TECHNICAL SERVICE BULLETIN

Product: Cornelius Viper

Subject: Condenser Fan PN replacement 620073140

Date: 10/22/2021

Damaged Fan Blade

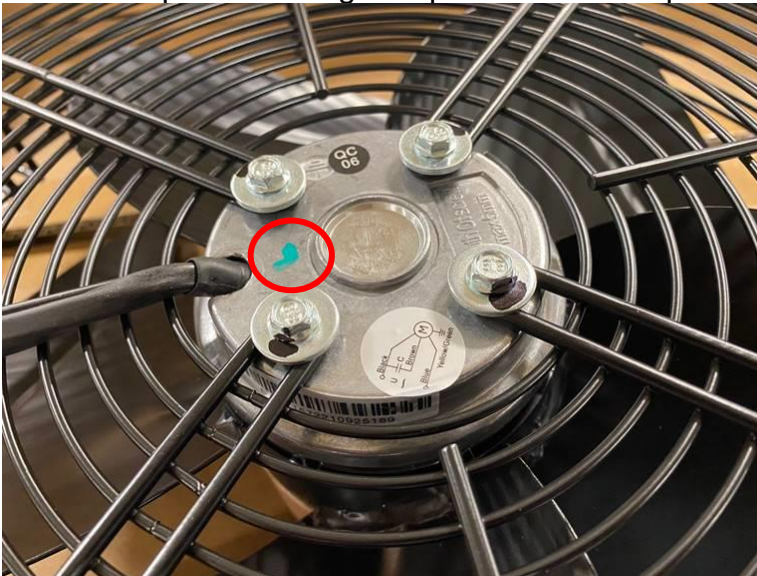
On a small percentage of Viper units, there is potential for the fan blade to develop a fracture or crack near the fan blade hub. While this condition does not create a safety risk; if left unrepaired it could require additional repairs to the shroud or condenser components.

Improper attachment of fan blades to condenser fan motor.

The issue will usually be accompanied by excessive / metallic fan noise, visible vibration of the fan cage, or system errors as noted below:

If identified, immediately shut down the unit to avoid further damage.

- Replace the damaged fan, using replacement fan PN: 620073140. Identification for new fan is a presence of green paint mark as depicted below:
